# UNITED STATES PATENT AND TRADEMARK OFFICE

APPLICATION NO.	FILING DATE	FIRST NAMED INVENTOR	ATTORNEY DOCKET NO.	CONFIRMATION NO.
10/776,218	02/12/2004	Raul Montanana	3011-1002	3173

<b>Office Action Summary</b>	<b>Application No.</b>	<b>Applicant(s)</b>	
	10/776,218	MONTANANA, RAUL	
	<b>Examiner</b>	<b>Art Unit</b>	
	Saúl J. Rodriguez	3681

This is a first office action on the merits of patent application S. N. 10/776,218.

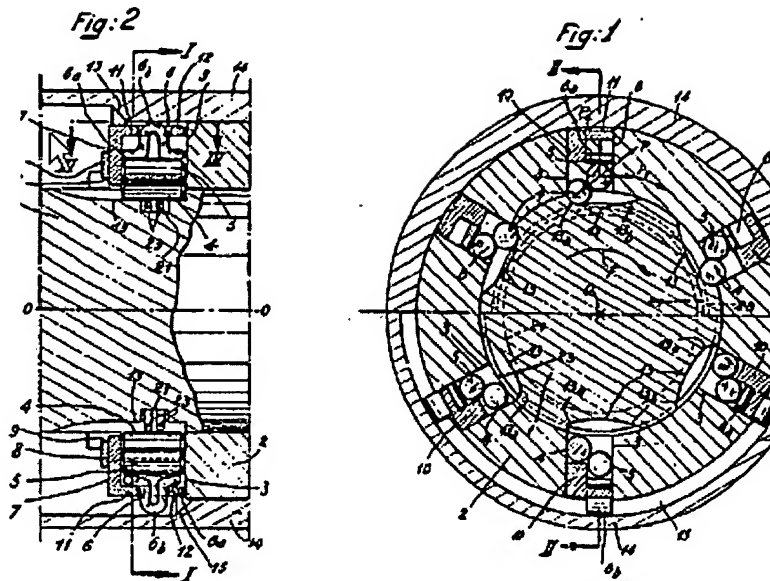
Claims 1-3 and 5-7 are rejected under 35 U.S.C. 102(b) as being anticipated by FR ('579).

FR ('579) discloses a positive engagement clutch comprising an input side, an output side, a torque input member, a torque output member, first engagement members (4), second engagement members (5), a common axis, projecting and retracting positions, a gap, and bearings.

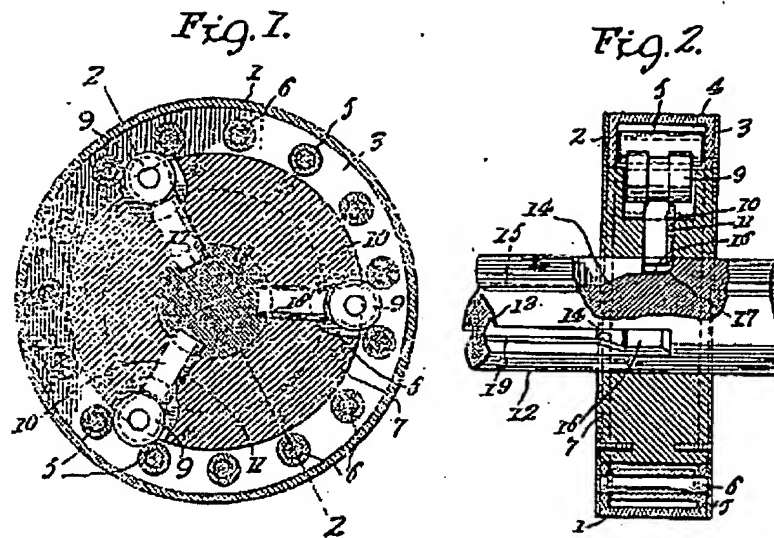
Claims 1 and 3-7 are rejected under 35 U.S.C. 102(b) as being anticipated by FR ('290).

FR ('290) discloses a positive engagement clutch comprising an input side, an output side, a torque input member, a torque output member, first engagement members, second engagement members, a common axis, projecting and retracting positions, a gap, rollers (9), a push rod element (16).
